**FARRAGUT VISUAL RESOURCES REVIEW BOARD
AGENDA**

MEMORANDUM

TO: Farragut Visual Resources Review Board
FROM: Bart Hose, Assist. Community Development Director.
SUBJECT: Regularly Scheduled Meeting - Tuesday, July 27, 2021, at 7:00 p.m.

OLD STAGE FARM
ENTRANCE MONUMENTS

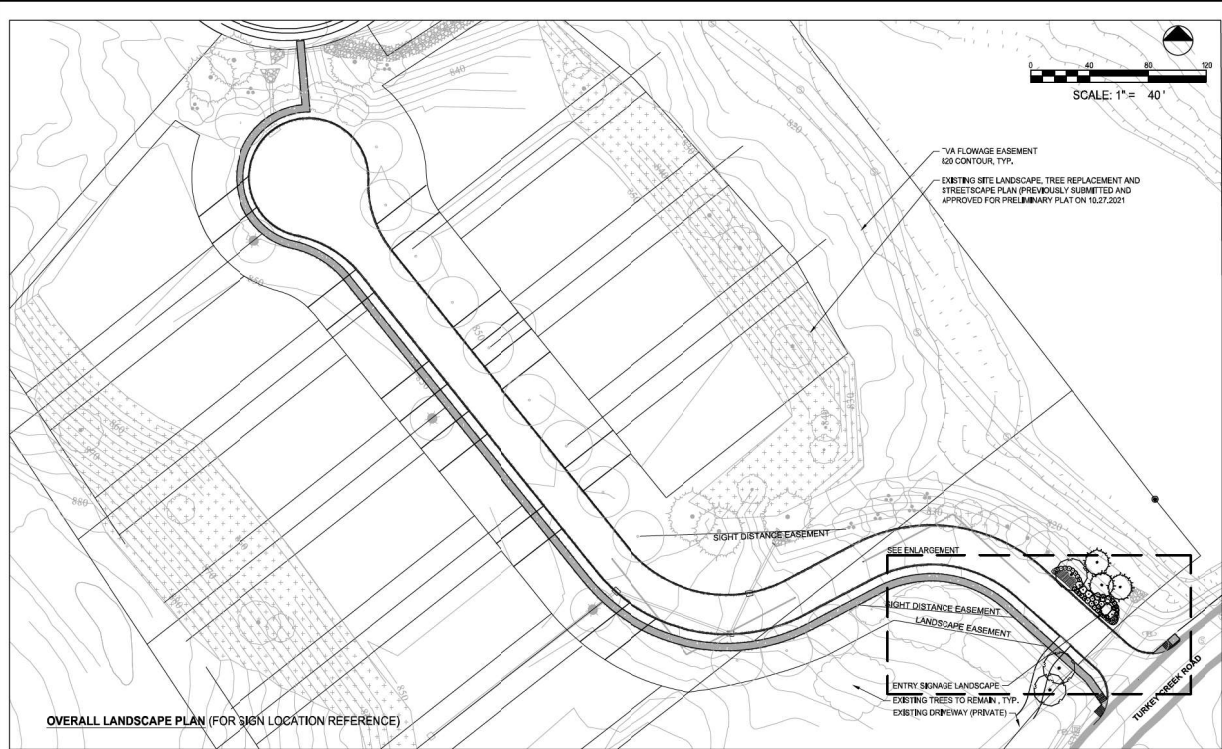
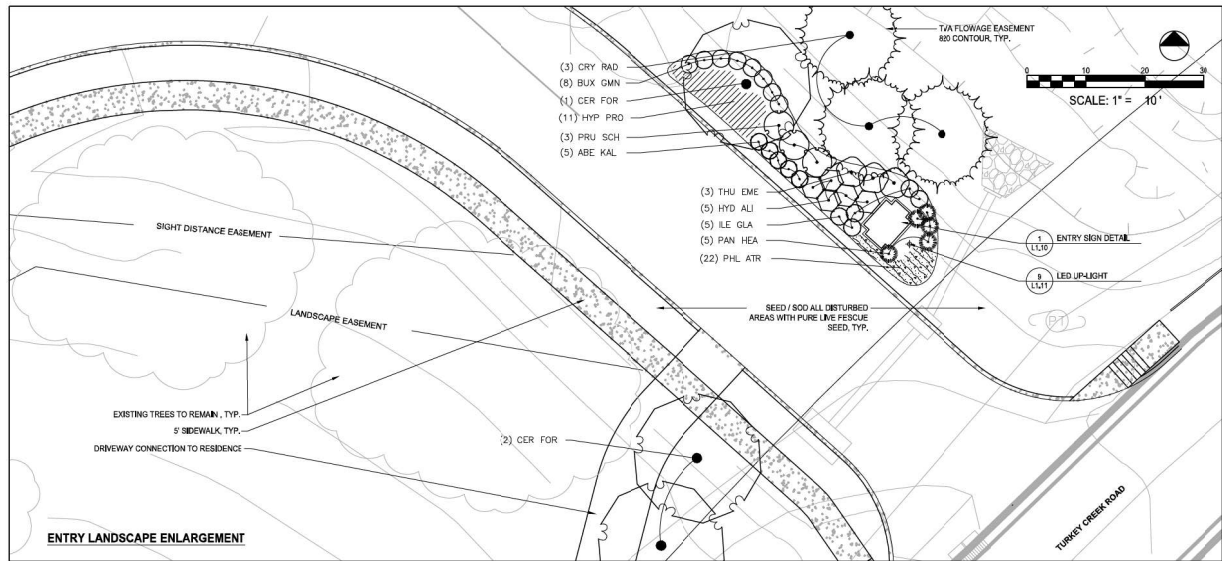
Old Stage Farms Subdivision is requesting approval for two permanent ground mounted signs located at the subdivision's entrance off of Old Stage Road. Each sign face is approximately 3.6 sq. ft. in size and would hang from a wood post and support arm mounted atop a brick column. The sign structure(s) are located within platted sign easements on each street corner. Landscaping around the sign is also included.

The staff recommends approval of the sign subject to a survey being required to document that the installed sign meets all setback and other applicable standards.

SHEET TITLE
VRRB - ENTRY SIGN DETAILS

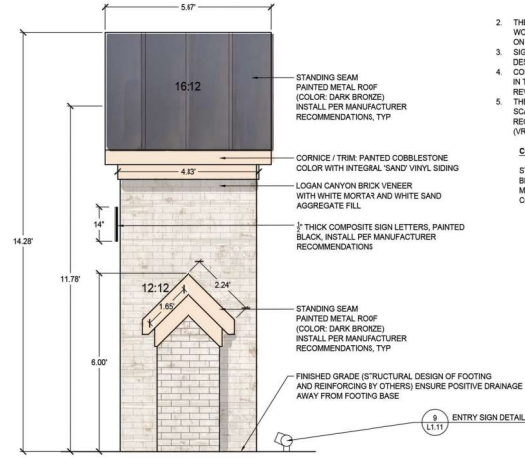
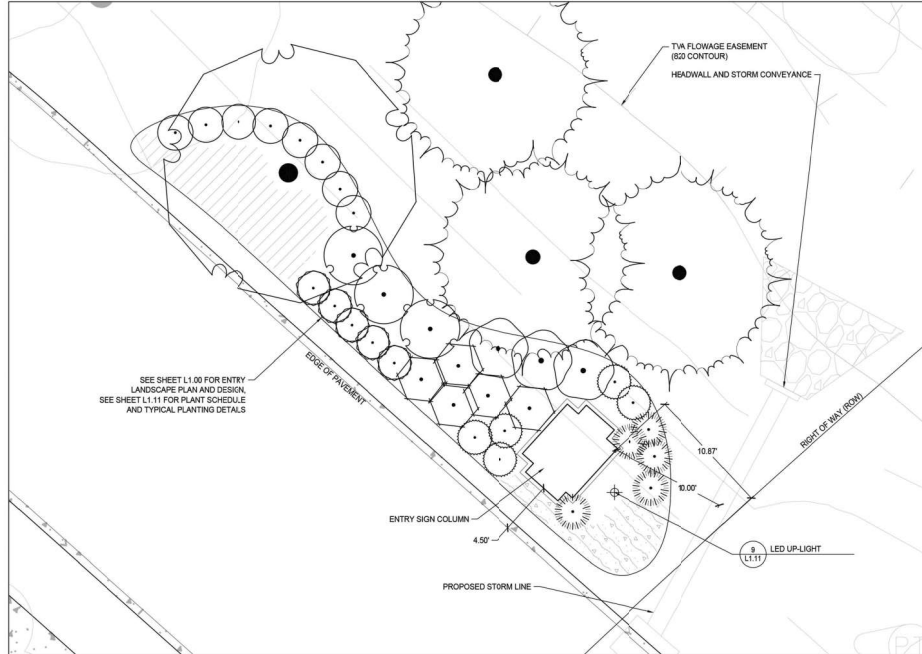
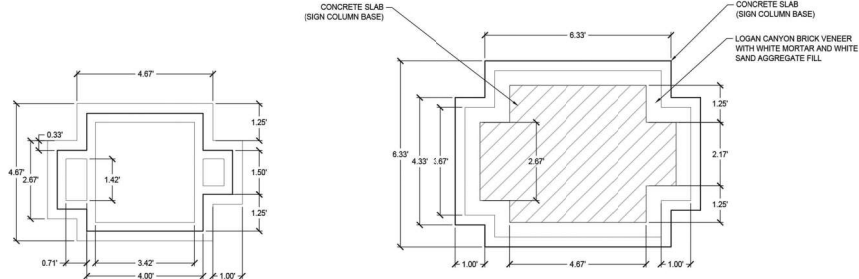
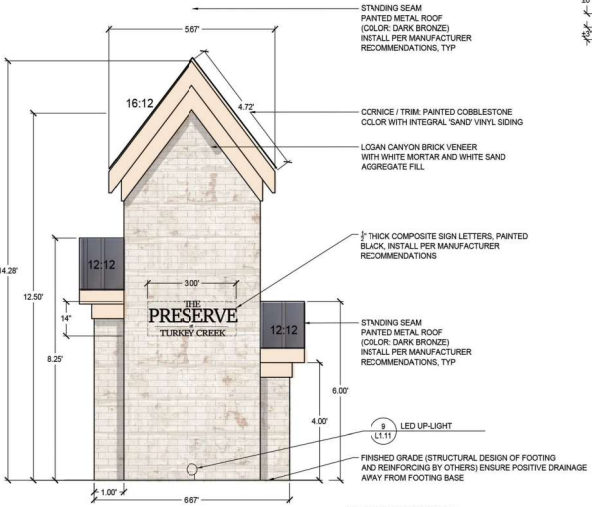
The Preserve at Turkey Creek Subdivision is requesting approval for a permanent ground mounted sign located at the subdivision's entrance off Turkey Creek Road. The application also includes a request to place the sign in the public road right-of-way (ROW) of Painted Turtle Lane, the subdivision's new entrance road. The sign is proposed to be located on a larger ornamental entranceway structure.

The Sign Ordinance allows for such signs to be located within the right-of-way provided they are part of a streetscape plan submittal. The use of the right-of-way and plan must be reviewed and recommended to the Board of Mayor and Alderman for approval by both the Planning Commission and VRRB. The VRRB must also review and approve the actual ground sign as it would any other similar proposal. The Planning Commission recommended approval of the ROW location as part of the final plat approval process at its July 15th meeting.

The staff has reviewed the sign plan and the right-of-way location seems reasonable given the existing conditions in the entranceway area, and the fact that the sign and its associated support structure and landscaping are part of a larger streetscaping plan for the development. The staff recommends approval of the sign subject to a required as-built survey documenting its constructed location, ensuring that its location does not conflict with any installed or planned utilities, and the execution of an on-going liability/maintenance agreement for the sign and required landscaping between the developer/HOA and the Town. This recommendation includes both the design of the sign and the VRRB's recommendation of the ROW location to the Board of Mayor and Aldermen.

Landscape Plan for the Old Stage Farms Subdivision located off Old Stage Road.

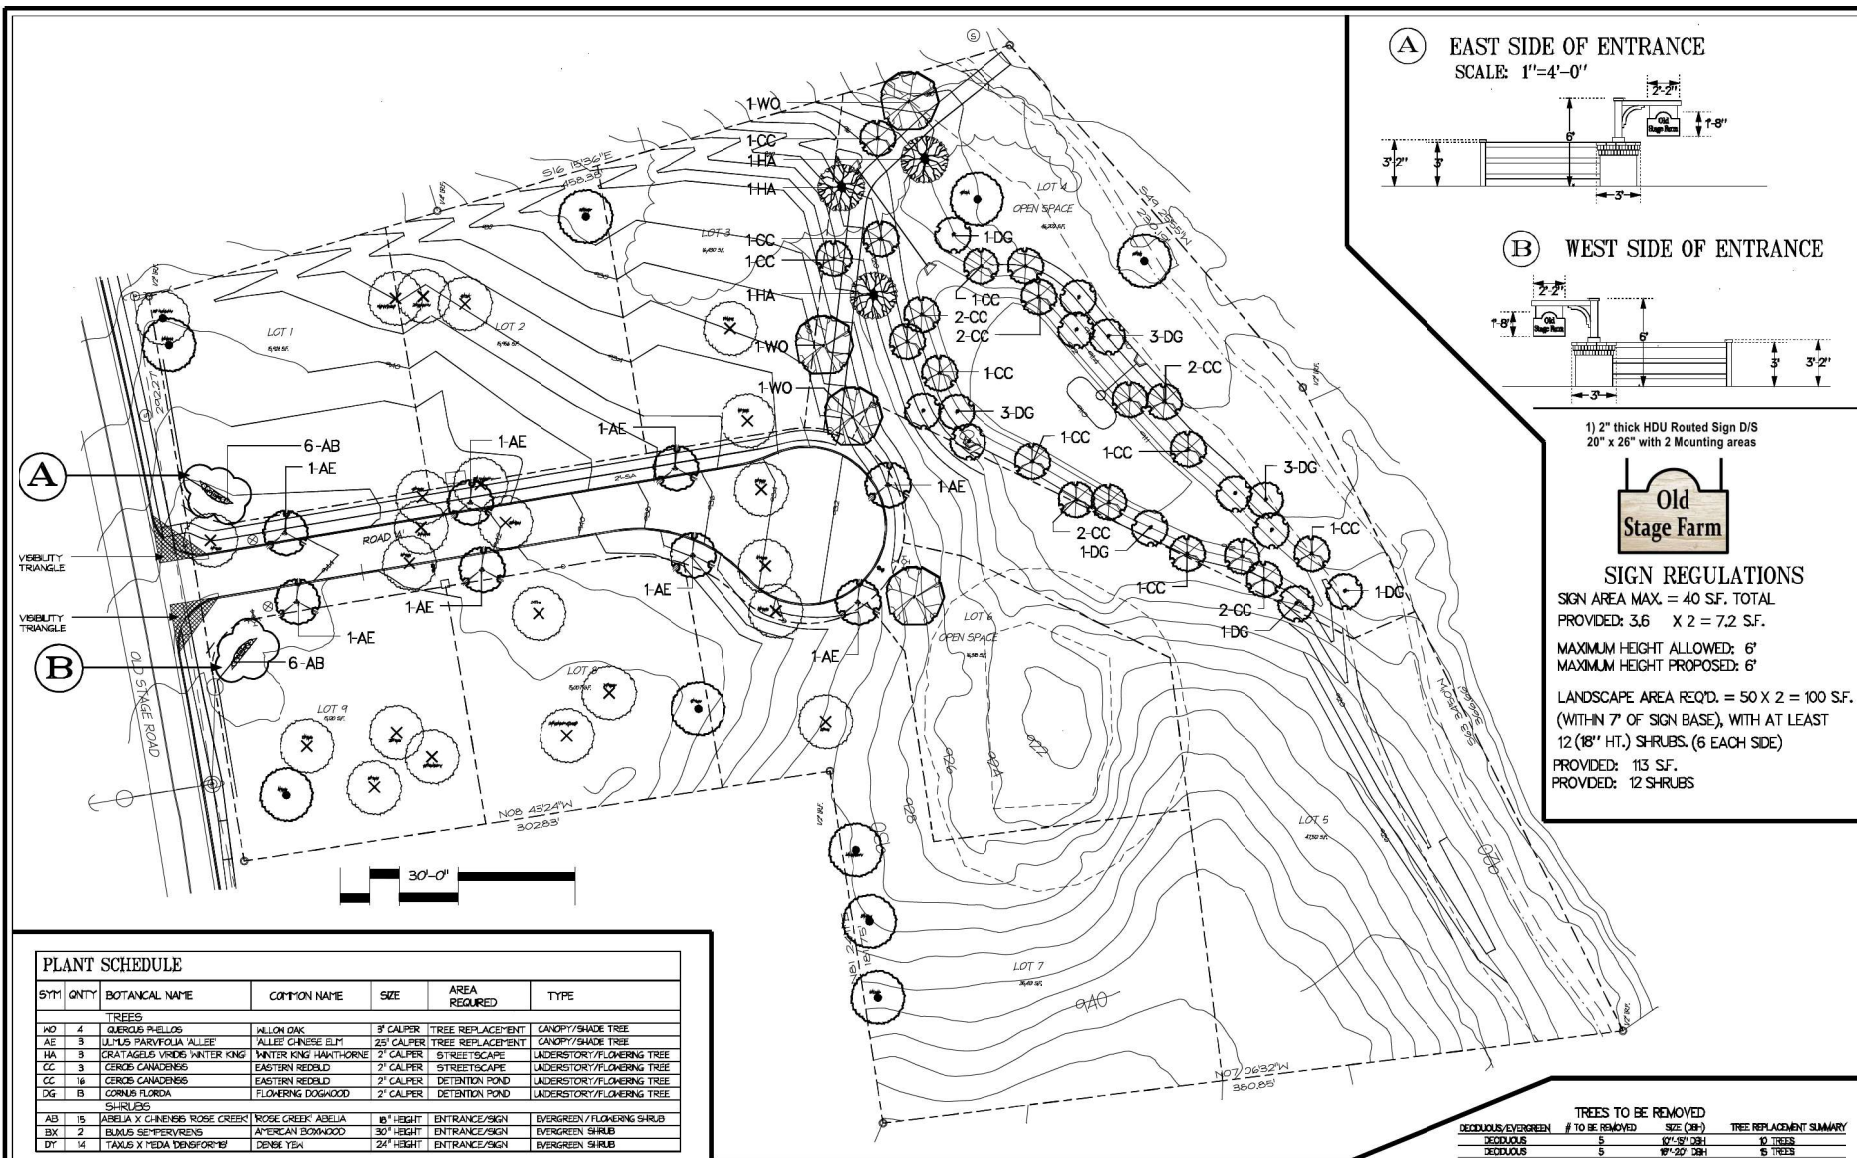
This item involves a required landscape plan for Old Stage Farms Subdivision. The plan includes the required landscaping elements for the stormwater detention basin and required replacement trees along the walking trail connection. The plan also depicts streetscape plantings and the entrance signs, which were/are approved separately.

The staff recommends approval.
